### CHANGING FUSIBLE LINKS

During 2019 the design of the Fusible Link was changed from Type "A" to Type "B" as shown below.

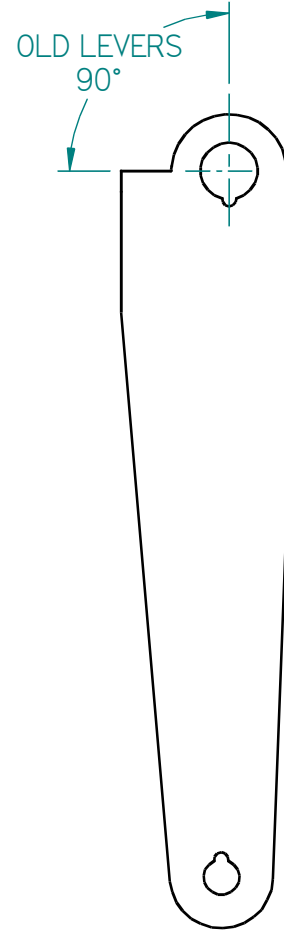
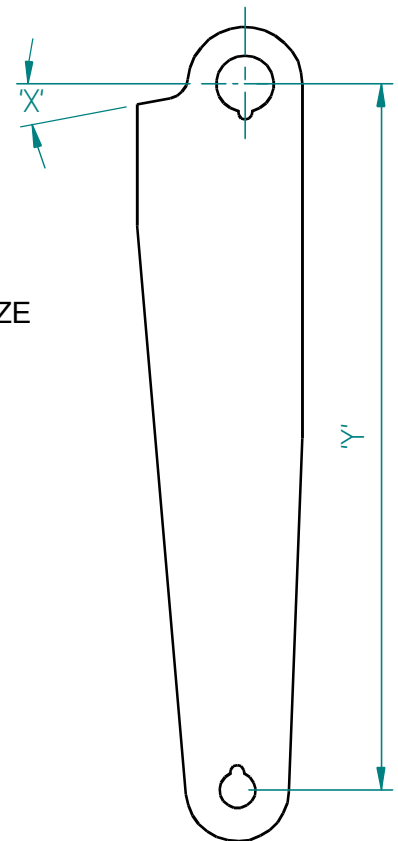
Type "A" links are no longer available, therefore if replacement is necessary, the Type "B" link must be used.

Because the Type "B" link is shorter than Type "A", it must be used in conjunction with the later type Connecting Lever: Old Connecting Levers have their contact face at 90° to the lever axis, whereas new levers have this face angled as shown below.

Type "B" links, and new Connecting Levers are available from Kinetrol under the spare part numbers shown below. Type "B" links are common across the 05, 07, 09 and 12 model range, but Connecting Levers are model specific. The "D-Link" (SP845) is also available in case of loss or damage.

#### TYPE 'B': 74°C SP838 100°C SP839

SP842 (05&07), SP843 (09), SP844 (12)
